BWVRVIP-1 4NP-A: BWR Vessel and Internals Project

Evaluation of Crack Growth in BWR Stainless Steel RPV Internals

1016569NP

Final Report, January 2009

Figure 1
Throughwall variation of the stress intensity factor K for various cylinder-to-cylinder and cylinder to edge-ring welds based on the corresponding residual stress distributions reported in BWRVIP-14 and in independent calculations by Battelle.

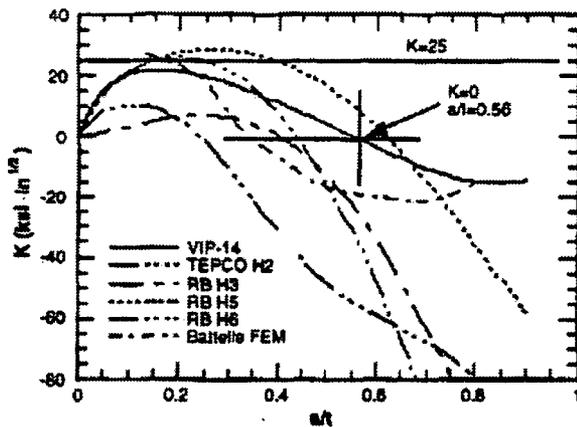
BWRVIP-14 presents residual stress calculations and measurements on a number of core shroud cylinder-to-cylinder welds and cylinder-to-edge-ring welds. It also defines a generic residual stress distribution for such welds. The calculated and measured distributions are compared in Figs. 4-4 through 4-11. It can be difficult to interpret whether one throughwall residual stress distribution is conservative with respect to another. It is much more meaningful to compare the corresponding distributions of K , because it really controls the crack growth. The throughwall variation of the stress intensity factors which correspond to the various throughwall residual stress distributions given in BWRVIP-14 are shown in Fig. 1. The K solution corresponding to the "generic" BWRVIP residual stress distribution is bounding in the sense that it predicts crack arrest at a larger depth than all but one of the distributions, the values in the positive portion of the curve are greater than those of the other distributions at most locations, and it is less compressive for deep cracks so that any prediction of crack arrest in the presence of additional stresses is conservative.

- Item 4 pg.2: The BWRVIP in its response defines a new K distribution (Fig. 4 of the BWRVIP response) that it argues can be used on a generic basis for core shroud horizontal welds to determine K distributions that can be used with K dependent CGR models such as the BWRVIP-14 correlation or PLEDGE.

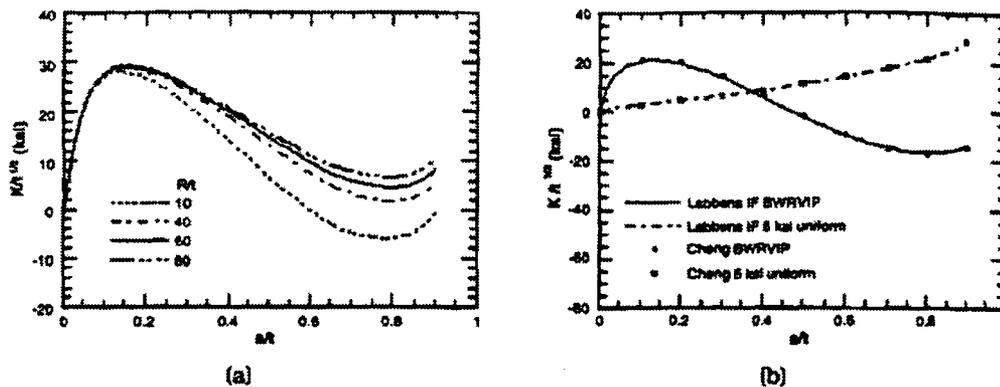
The BWRVIP response does recognize that the proposed distribution need not be bounding at every location. They argue that the local regions where the stresses could be higher are limited in extent and hence do not affect the overall structural integrity. If the cracking is limited in extent and the crack size much smaller than the critical size for failure, the BWRVIP argument is valid, but in such cases one could probably just use the bounding CGR approach. If the crack size is close to critical, then the sizes and nature of the local regions in which the stresses are more severe than assumed by the BWRVIP could be more important. Local perturbations in stress can have dramatic effects on CGRs. From Figure 5 in the BWRVIP response, it can be seen that an increase of 1 ksi in the average throughwall stress could reduce the time required for the crack to grow throughwall from 30 years to 5 years.

There is substantial experience in the calculation and measurement of residual stresses for "good" welds. There is much less information available on the nature and distribution of the local stresses due to repairs. In the ANL TLR on BWRVIP-14, the approach taken was to assume that experience permits a good estimate of a bounding CGR, in particular 2.2×10^{-5} in/h, which corresponds to 0.2 in/y. The throughwall average stress which had to be added to the generic welding residual stress to obtain this average CGR was ≈ 10 ksi. As the BWRVIP response notes such a stress state could not exist over the entire circumference, but it was intended to be used to estimate CGR only in local weld repair regions. It probably would have been simpler to just state that the bounding CGR should be used in local weld repair regions and a "best estimate" CGR used elsewhere.

As the BWRVIP has noted in its response to an earlier RIA on BWRVIP-14 and in the response to the staff SER, the stress intensity factor solutions in BWRVIP-14 using the Bamford and Buchelet weight functions, which were determined for $R/t = 10$ may give significantly nonconservative values for K and should not be used. The BWRVIP has presented improved stress intensity factor solutions based on the work of Cheng and Finnie. These solutions take into account the R/t ratio and have been benchmarked with the solutions by Labbens and Bamford and Buchelet for $R/t = 10$ and the limiting case of the flat plate ($R/t = \infty$) for a variety of stress distributions. In Fig 2a are shown the K solutions for $R/t = 10, 40, 60, 80$ for the proposed generic weld residual stress in the BWRVIP response to the SER. The solutions for $R/t = 10$ are nonconservative. They predict arrest for the new generic stress distribution, whereas the solutions for $R/t \geq 40$ predict throughwall crack growth.

Figure1: BWRVIP Generic Stress Intensity Factor Distribution for Core Horizontal Core Shroud Welds (Residual +3.2 ksi Membrane Stress + Surface Stress)

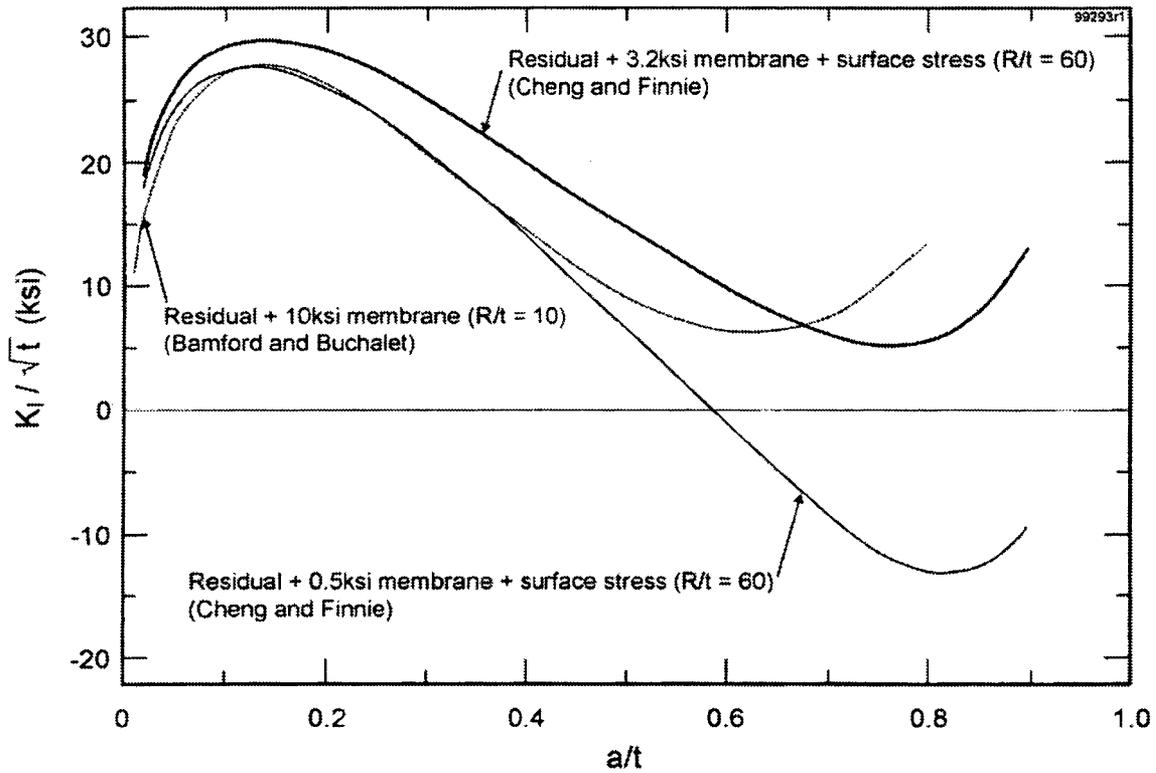
In the SE, the NRC took exception to the BWRVIP conclusion that the use of the generic stress intensity factors proposed in Figure 4 of the November 24, 1998 RAI response [2] avoids the need to document weld repairs when using a K-based approach for estimating crack growth rates. During the meeting, the BWRVIP stated that the generic stress intensity factor (K) distribution proposed by BWRVIP in November 1998 was conservative because of the following factors:

The generic K distribution is shown in Figure 1. It is more conservative than a distribution based on the Bamford-Buchalet model (which includes a membrane stress of 10 ksi). The generic K distribution remains positive through the thickness and predicts crack retardation but not arrest. This prediction is conservative because inspection data from core shrouds shows evidence of crack arrest.

- (c) As can be seen from Figure 1, the fracture mechanics model used for the determination of K is limited to 90% of wall. Hence, the choice of 80% ensures that the limit of the model is not reached during K-dependent crack growth. It can be seen from Figure 1 that K remains relatively low between 80 and 90% of wall and even when extrapolated to 95% of wall, K is less than 25 ksi $\sqrt{\text{in.}}$ for a 2-inch thick shroud (which formed the basis for the constant rate of 2.2×10^{-5} inch per hour).

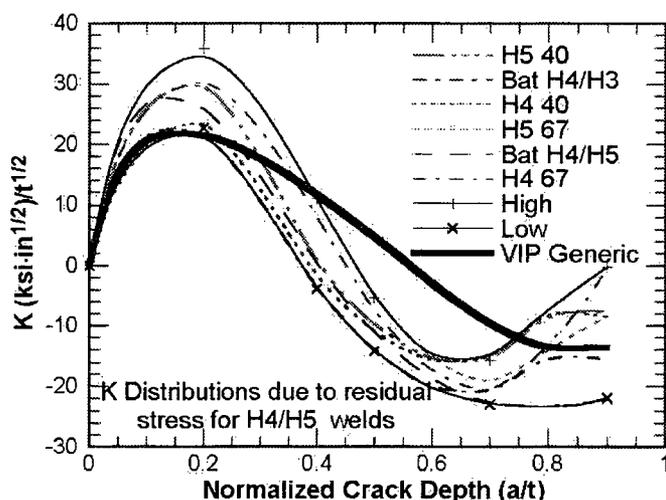
Rather than compare the residual stress distributions for the welds presented in BWRVIP-14 with the Battelle results, it is more meaningful to compare the resulting throughwall distributions of the stress intensity factor K since it is K that actually governs the crack growth. In Figure 1, the K distributions determined from the computed residual stresses for shell-to-shell welds given by BWRVIP-14 are compared with the K distributions determined from the residual stresses computed by Battelle. The BWRVIP-14 results are given for two values of the yield stress, 40 and 67 ksi. Although the modeling assumptions and computation approaches used for the BWRVIP-14 calculations are significantly different than those used in

the Battelle calculations, the K distributions are quite similar in character. The differences between the various solutions reflect in some cases a variation in a significant parameter (the yield stress) and in others model uncertainty. Bounding K solutions were obtained by determining the maximum and minimum values for K at each depth from the six computed solutions.

Figure 2. Computed (40 and 67 ksi yield) and measured axial residual stress in the HAZ of an H5 weld (cf. Figure 4-4 BWRVIP-14.)

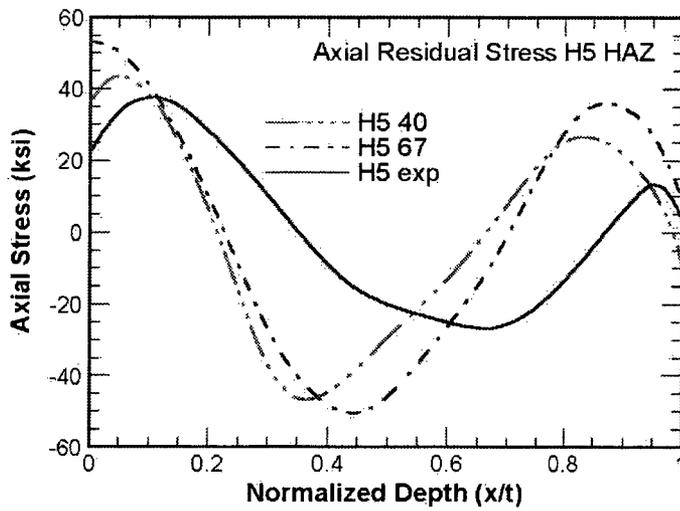
In addition to calculated values of residual stresses, BWRVIP-14 has measurements of residual stresses for a shell-to-shell weld from a core shroud from a cancelled plant. The measured residual stresses are compared with the computed residual stresses in Fig. 2. BWRVIP-14 states (pg. 4-10) "in general, the analytical predictions have the same through-wall shape as the experimentally measured distributions; with tensile stresses on the inside and outside surfaces and compressive stresses in the middle half of the shroud wall."

Figure 3. K distributions for the computed and measured residual stresses in H5 welds

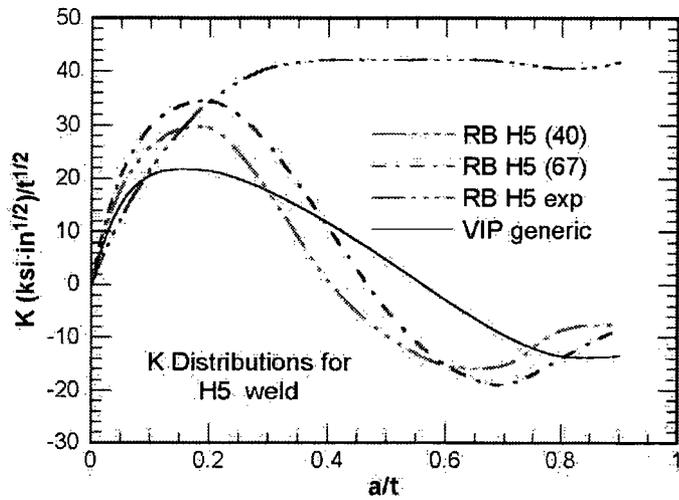
The corresponding K distributions shown in Fig. 3, however, are very different in character. The K distributions based on either the BWRVIP or the Battelle analytical predictions of the weld residual stresses suggest that there is a high likelihood that cracks will arrest approximately half way through the wall. The K distribution corresponding to the measured residual stresses suggests rapid throughwall growth.

Figure 4. (a) Total, parting out, and self-equilibrating axial residual stress H5 weld; (b) K distributions corresponding to the total, parting-out, and self-equilibrating residual stresses.

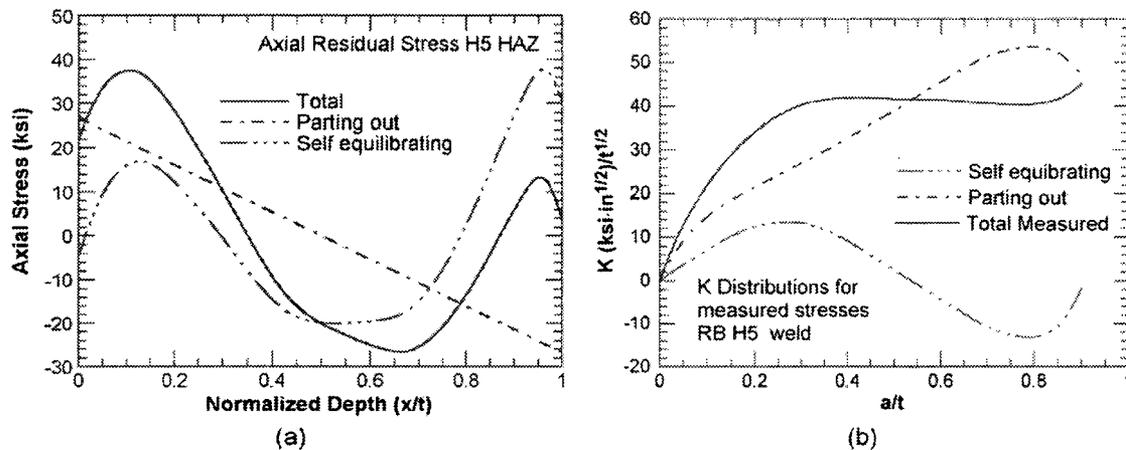
The residual stresses measured on the H5 weld consist of a self equilibrating portion and a portion corresponding to the net moment relieved when the specimen for the throughwall analysis was removed from the shroud. The total residual stress is the sum of these two stresses. The different contributions to the residual stress are shown in Fig. 4a and the corresponding K distributions are shown in Fig. 4b.

Figure 5. (a) Comparison of the BWRVIP generic weld profile and the reported measured profile for an H5 weld; (b) Comparison of the corresponding K distributions.

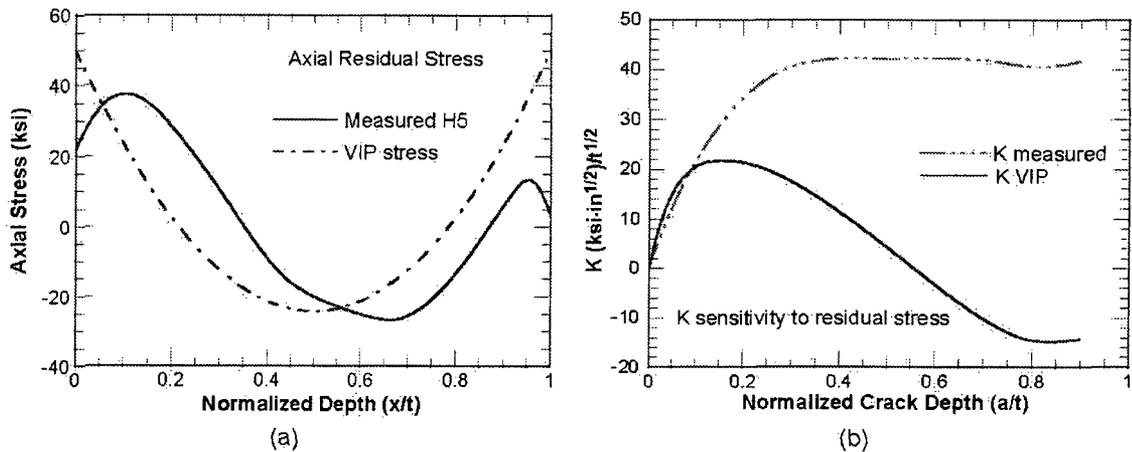
BWRVIP-14 also describes residual stress calculations and measurements on ring-to-shell welds. No calculations are explicitly made for these stress distributions and weld geometries. Instead the argument is made the generic residual stress distribution is a reasonable representation of axial through-wall residual stress distribution for all the shroud welds for safety evaluation purposes. However, as shown in Figs. 5a and 5b, "reasonable" agreement between stress profiles is not a guarantee of reasonable agreement between K distributions.

Figure 9. Distributions of total K for H4/H5 welds.

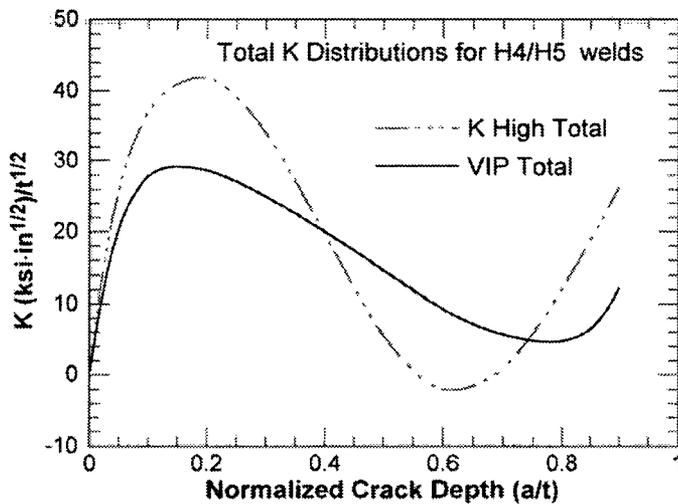
The K distribution corresponding to the bounding value of K due to weld residual stresses shown in Fig. 1 and the added surface, applied, and weld repair loads is shown in Fig. 9 along with the generic BWRVIP-14 K distribution for the total stress. In the critical region in the midsection of the wall, the BWRVIP distribution is more conservative than the total K based on the bounding K solution for residual stresses in the H4/H5 welds. The VIP solution does not bound the shell-to-shell K distributions at every depth. Thus for very shallow cracks, The BWRVIP solution may underpredict the growth of shallow flaws for some period of time. However, it is more conservative than these distributions in the sense that it predicts complete throughwall growth of an initial $a/t = 0.25$ depth, while the bounding solution for the shell-to-shell welds predicts arrest of an initial $a/t = 0.25$ crack in every case. The depths for arrest based on a range of assumptions about the residual and applied stresses are shown in Table 1. The results suggest that cracks in shell-to-shell welds would be expected to arrest at depths ranging from 0.37 to 0.56 of the wall thickness. Of the reported depths for H4/H5 welds in BWRVIP-14, only one exceeds $0.56 a/t$ in depth, and that reported depth is only 0.57 so within measurements errors it is also consistent with the results in Table 1.

Figure 10.
ANL data on crack growth rates in base metal of irradiated stainless steels

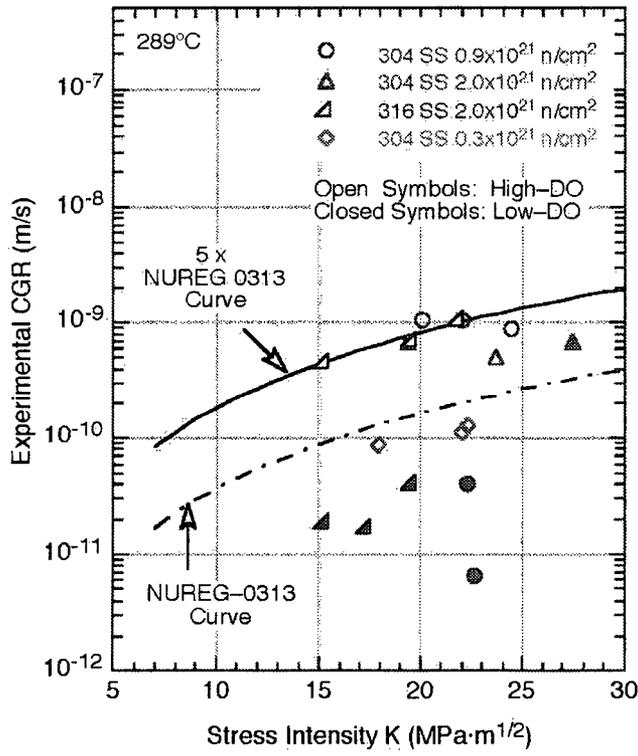
Data on crack growth rates for irradiated base metal are shown in Fig. 10. The BWRVIP-14 95th percentile curve for a conductivity of $0.15 \mu\text{S}/\text{cm}$ lies slightly below the NUREG-0313 curve (see Figure 3-9, pg. 3-81 of BWRVIP-14). In Figure 10, it would lie just below the data for the irradiated 304 SS with a fluence of $0.3 \times 10^{21} \text{ n}/\text{cm}^2$. Most of the available data are for fluences of $10^{21} \text{ n}/\text{cm}^2$. In these case crack growth rates are about five times higher than the NUREG-0313 curve. Although the base metal data for a fluence of $0.3 \times 10^{21} \text{ n}/\text{cm}^2$ in Fig. 10 lies below the NUREG-0313 curve, the HAZ crack growth rates in Fig. 11 are a factor of five or more above the NUREG-0313 curve.

Although the data are limited, it would seem that it would be reasonable to assume that the distribution (i.e., both the median and the 95th percentile) for unirradiated stainless steel crack growth rates shifts a factor of five higher for a fluence of $5 \times 10^{20} \text{ n}/\text{cm}^2$. This would be conservative for lower fluences. The 95th percentile of unirradiated distribution (i.e., the BWRVIP-14 disposition curve) then lies 0.509 standard deviations above the median of the irradiated distribution. This makes it the 70th percentile of the irradiated distribution for a fluence of $5 \times 10^{20} \text{ n}/\text{cm}^2$.

Figure 1. Predicted Crack Growth in Core Shroud Ring-to-Shell Welds

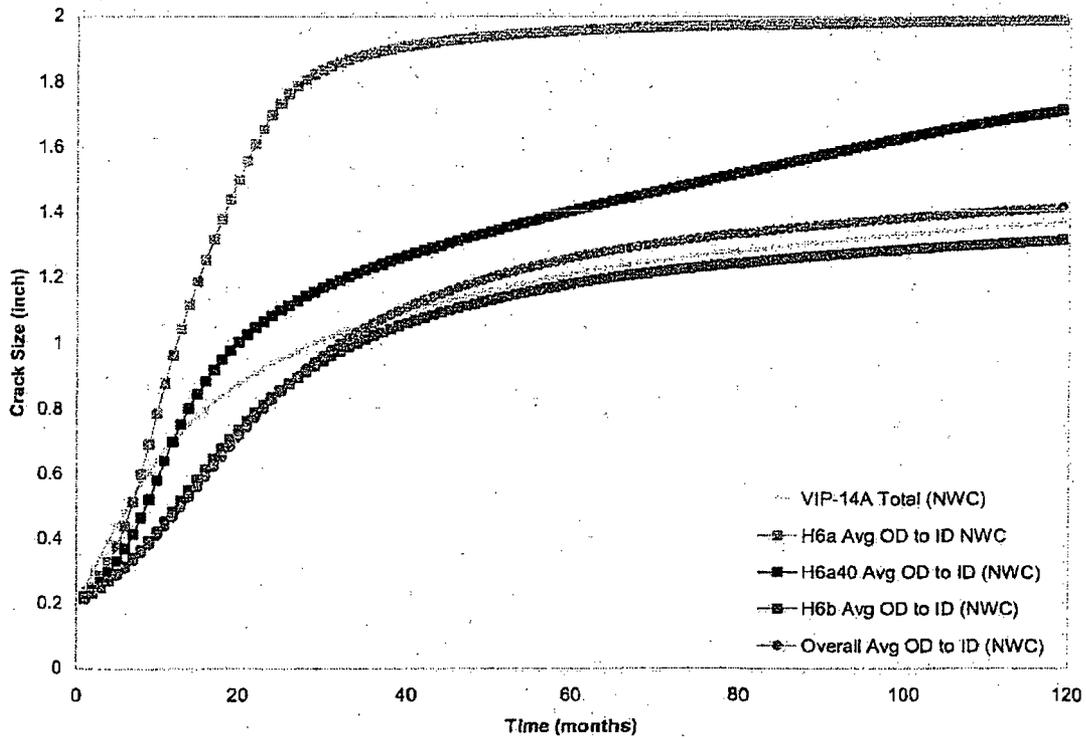
Based on the combination of the K-distribution developed by the BWRVIP for H6a welds and the BWRVIP-14-A crack growth rate model (denoted as "H6a Avg OD to ID NWC" in Figure 1), an outside diameter (OD) to inside diameter (ID) crack in the H6a weld takes approximately 22 months to grow from 10 percent to 80 percent through-wall. The combination of the BWRVIP-14-A generic K-distribution and the BWRVIP-14-A crack growth rate model (denoted as the "VIP-14A Total (NWC)" crack growth curve) predicts that it will take approximately 214 months to grow from 10 percent to 80 percent through-wall under normal water chemistry. It should be noted that the generic K-distribution (used to calculate the "VIP-14A Total (NWC)" crack growth curve) includes operational loads and contributions intended to represent the effect of local stresses. The other projected crack growth curves shown in Figure 1 (i.e., "H6a Avg OD to ID NWC") based on other, specified K-distributions do not include any contribution from operating stresses. Including these operating stresses would further increase the difference between the growth predicted by the BWRVIP-14-A generic K-distribution and the H6a (core shroud ring-to-shell weld) K-distribution.

Figure 2. Times for Growth to 0.8h for Three Different Distributions of Stress Intensity Factor.

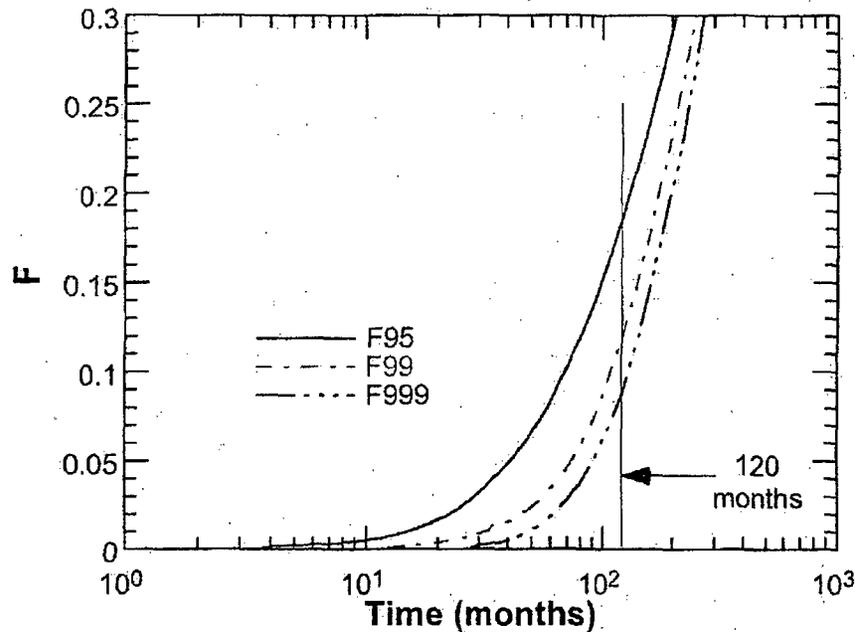
Monte Carlo calculations were performed by taking a sample from the failure time distribution and a sample from the crack growth rate distribution, and using the crack growth rate value to scale the time sample (which was computed using the BWRVIP crack growth rate 95th percentile correlation). The Monte Carlo samples can then be rank ordered to estimate the probability of failure, i.e., growth to $0.8h$, by a given time. Calculations are shown in Figure 2 for cases where the time for growth to $0.8h$ corresponding to the H6a stress intensity distribution is taken as the 95th, 99th, and 99.9th percentile value of the distribution. For the 95th percentile case, the probability that the crack has grown to $0.8h$ through-wall is 0.17 and the probability that no cracking this deep would have occurred in any of the 26 cases is 0.007.

This is too low to be statistically plausible. For the 99th percentile case, the probability that the crack has grown to 0.8h through-wall is 0.11 and the probability that no cracking this deep has occurred is 0.05. While low, this is considered statistically possible and the conclusion is that the H6a K-distribution represents the 99th or higher percentile of the K-distributions observed in service. The value of 214 months for the BWRVIP-14-A generic K-distribution and 95th percentile crack growth rate corresponds to the 25th percentile of the F99 distribution. Thus it would give conservative answers greater than 75 percent of the time. The crack depth would exceed 0.8h less than 11 percent of the time.

These results support the assertion in the BWRVIP letter dated September 12, 2005, that the combination of the BWRVIP-14-A generic K-distribution and the BWRVIP 95th percentile crack growth rate curve will provide reasonably conservative estimates of through-wall growth of cracks even though they may not be bounding in all cases.
